STAFF REPORT
(ONE-STEP FINAL PLAT)

CASE NUMBER: SUB 2002-09 -- W.J.R. ADDITION

LOCATION: Northwest corner of MacArthur Road and Webb Road

VICINITY MAP

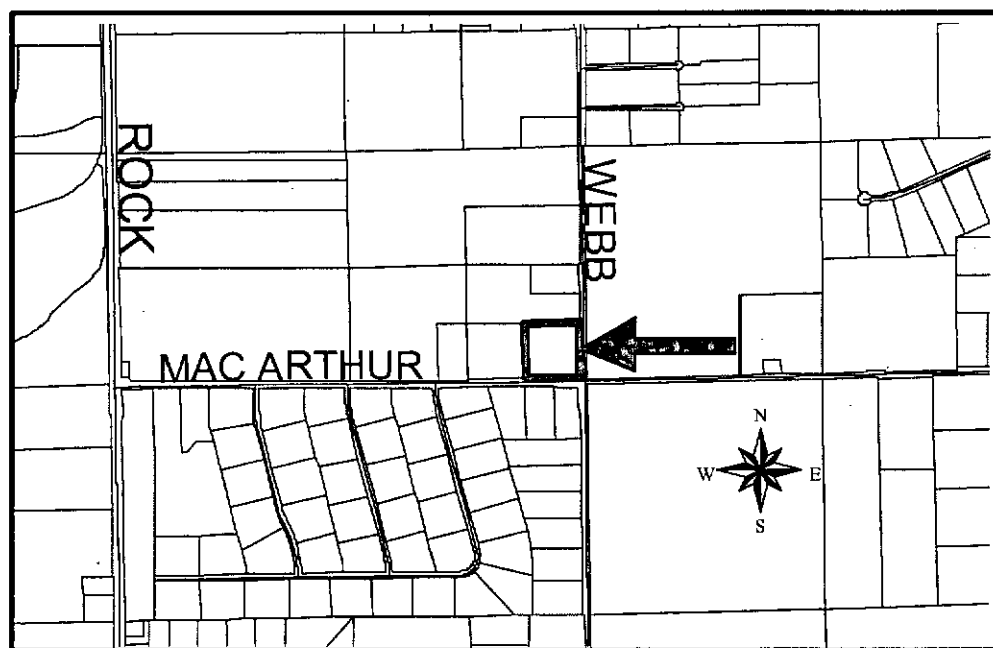
- A. Since sanitary sewer is unavailable to serve this property, the applicant shall contact the **County Code Enforcement** to find out what tests may be necessary and what standards are to be met for approval of on-site sewerage facilities. A memorandum shall be obtained specifying approval.

The size of both lots does not meet the 4.5 acres required by Subdivision Regulations/Zoning Code for lots served by sewage lagoons. A modification will need to be approved by the Subdivision Committee and an administrative adjustment also will need to be approved.

- B. The site is currently located within the Rural Water District No. 3. The applicant shall contact this water district to determine the ability of this property being platted to connect to their water line and submit a letter to MAPD and **County Code Enforcement** from the water district to that effect.

- E. **County Engineering** needs to comment on the status of the applicant's drainage plan. ***A drainage plan is needed. A cross-lot drainage agreement may be needed.***

- F. **County Engineering** needs to comment on the need for access controls. The plat proposes three access openings along Webb and one opening along MacArthur. Distances should be shown for all segments of access control. The final plat shall reference the dedication of access controls in the plat's text. ***County Engineering has required complete access control to Webb Road from Lot 2. 150 feet of complete access control along MacArthur is required from the intersection.***
